Access Compliance Report

Public Rights-of-Way

(Curb Ramps)

Intersection ID: 10039791	Main Street: TOLLESON_AV	Cross Street: N/A	Location: SW
ADA ID: 4A1B5A1018D6	Ramp Type: PerpDiag	Initial Pass/Fail: Fail	Overall Compliance: No
Severity Score: 12.5			
Codes/Mitigation Info/Possible Solution		Field Measurements/Component Compliance

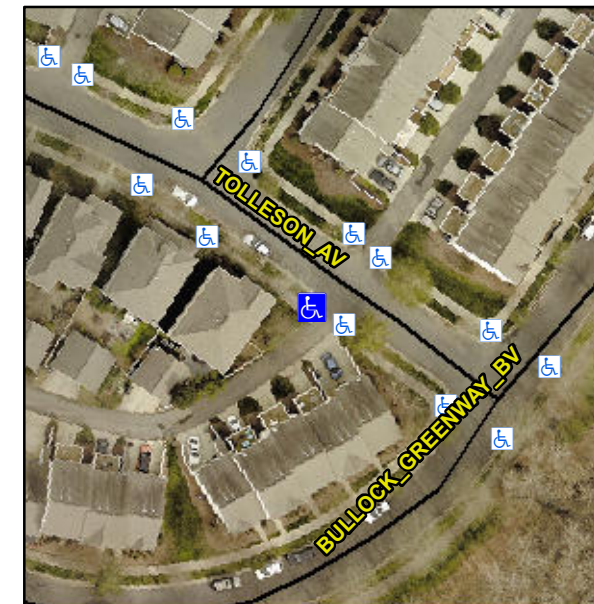
Not Found, R304.2.2

Compliance	Description	Data	Compliance	Description	Data
N/A	Ramp Length (in)	81.0	No	Ramp Slope (%)	8.7
Yes	Ramp Width (in)	87.0	Yes	Ramp XSlope (%)	1.6
N/A	Flare Type LT	N/A	N/A	Flare Type RT	N/A
N/A	Flare Slope LT (%)	N/A	N/A	Flare Slope RT (%)	N/A
N/A	Flare Traversable LT?	N/A	N/A	Flare Traversable RT?	N/A
N/A	Landing Length (in)	N/A	N/A	DWS Provided?	N/A
N/A	Landing Width (in)	N/A	N/A	DWS Contrast?	N/A
N/A	Landing Slope (%)	N/A	N/A	DWS Length (in)	N/A
N/A	Landing X Slope (%)	N/A	N/A	DWS Full Width?	N/A
N/A	Landing Curb? (Y/N)	N/A	N/A	DWS Offset (in)	N/A
N/A	Shared Landing?	N/A			
N/A	Gutter Ponding?	N/A	N/A	Gutter Slope (%)	N/A
N/A	Gutter Lip Ht (in)	N/A	N/A	Gutter X Slope (%)	N/A
N/A	Painted X Walk1?	No	N/A	Painted X Walk2?	No
	X Walk 1 Direction	To SE		X Walk 2 Direction	To NE
N/A	X Walk 1 Width (in)	N/A	N/A	X Walk 2 Width (in)	N/A
	X Walk 1 Slope (%)	2.3		X Walk 2 Slope (%)	0.5
	X Walk 1 X Slope (%)	1.4		X Walk 2 X Slope (%)	1.5

Remove & Replace Curb Ramp With Two New Directional Ramps or Equivalent.
